Re: Comments on Environmental Assessment (EA) and Finding of No Significant Impact (FONSI) for Proposed Holden Canyon Connector Road

The Center for Biological Diversity submits the following comments on U.S. Customs and Border Protection's (CBP) and Forest Service's (USFS) proposed Holden Canyon Connector Road Project as described in the November 2024 *Draft Environmental Assessment, Holden Canyon Connector Road Project, Tucson Sector* and CBP *Draft Finding of No Significant Impact for the Holden Canyon Connector Road Project, Coronado National Forest, Nogales Ranger District*.

Figure 1: The almost nonexistent “road segment 364” that clearly does not need “decommissioning”

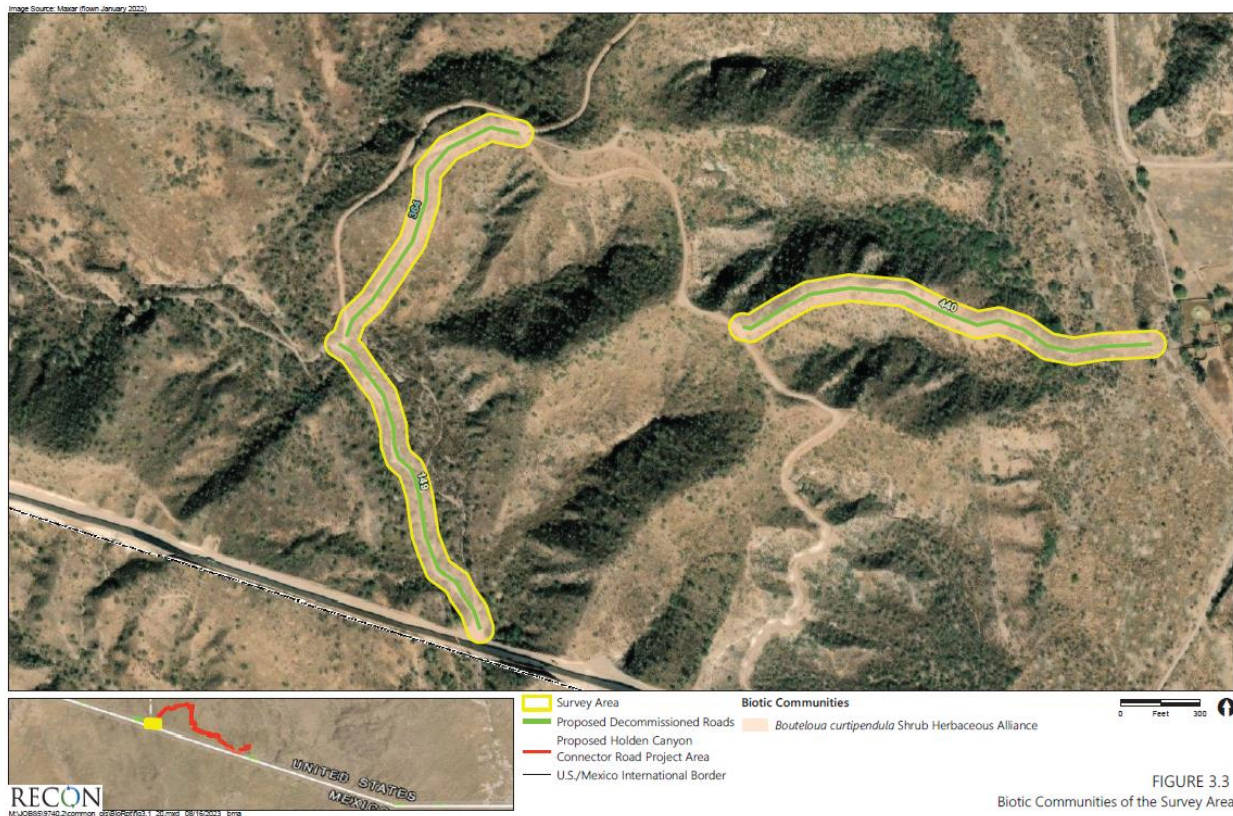
On-the-ground evaluation reveals that some road segments, such as "Segment 364" and "Segment 602" (presented in Figures 1 and 3 below) are virtually unrecognizable as roads and have not seen use in years or even decades. Yet these are some of the road segments that the Proposed Action would decommission to "offset" the construction of a new road through an entirely undisturbed area. This segment, listed as "Segment 364" in the Final Biological Resources Survey Report, is clearly not in need of any sort of "decommissioning." In fact, by eliminating well-established vegetation, displacing wildlife, disturbing soil and promoting soil erosion, the decommissioning activities of the Proposed Action would increase negative environmental impacts rather than being "beneficial" as the EA and FONSI allege.

CBP and USFS have failed to accurately and adequately analyze the impact (or so-called benefit) of road decommissioning, which is impossible to do unless the agencies take the ‘hard look’ necessary to understand the current conditions of each road segment. Worse, by falsely implying that these road segments are currently used, CBP and USFS’s analysis, taken together with omission of site-specific information, seems designed to actually mislead the public that both agencies serve. As demonstrated in the photograph of “Segment 364,” (Figure 1) and the

Figure 3: almost nonexistent “road segment 602”

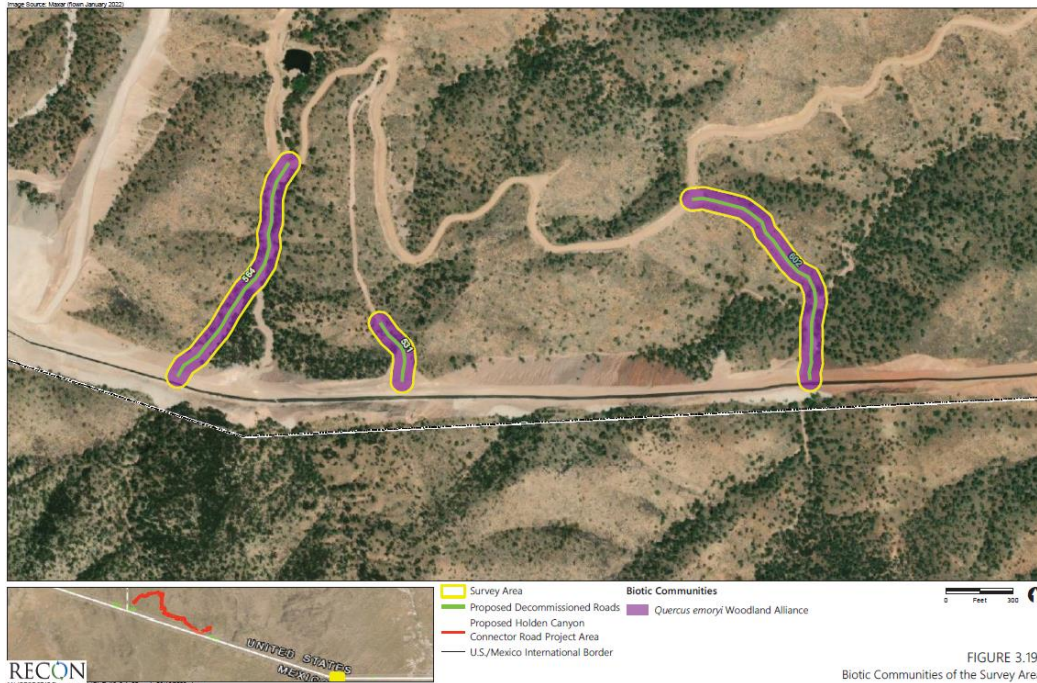
photograph of “Segment 602” (Figure 3, below), the Proposed Action’s road decommissioning component may result in additional environmental harm, rather than the purported benefits claimed in the EA.

Figure 5: Chiricahua Leopard Frog Critical Habitat and Holden Canyon Connector Road. Map by Curt Bradley, Senior Scientist and GIS Specialist, Center for Biological Diversity.

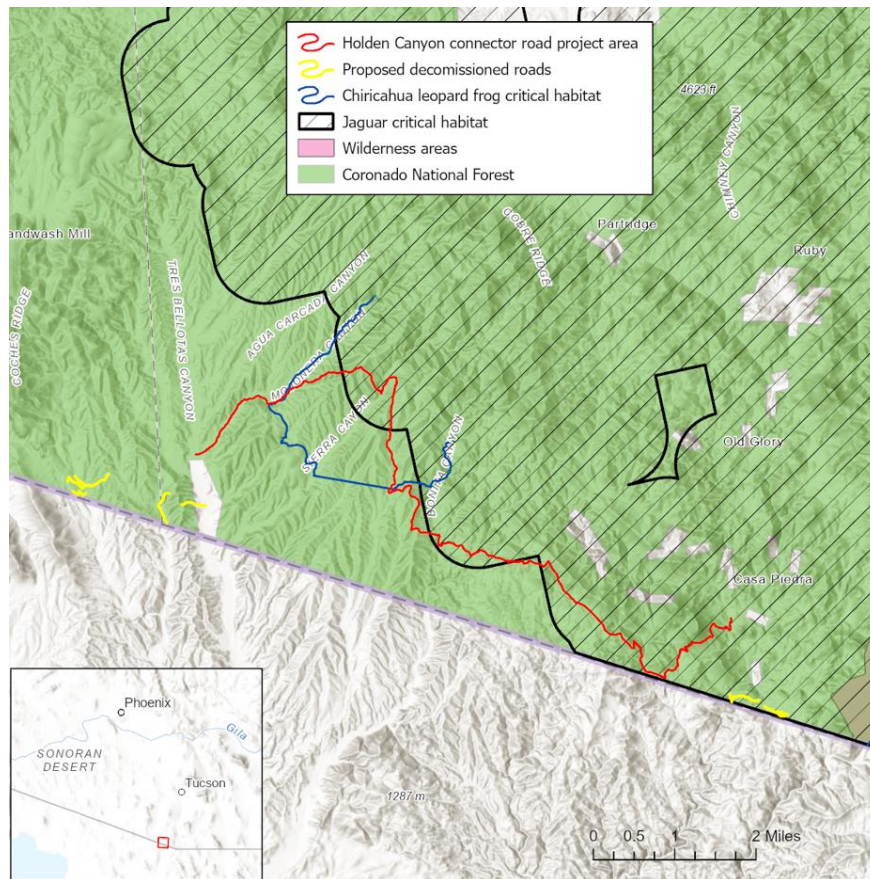
The Proposed Action cuts directly through federally designated critical habitat for the Chiricahua leopard frog (see figure 5, below). This critical habitat is already severely degraded due to existing threats, including poor management of grazing allotments by USFS. Construction, repair, and maintenance of the Holden Canyon Connector Road would further fragment habitat, reduce essential dispersal corridors, and increase the risk of vehicle-related mortality—all of which the EA fails to analyze. The EA also fails to consider the foreseeable

impacts of illicit off-road travel, a risk that will increase significantly as a direct result of the Proposed Action.
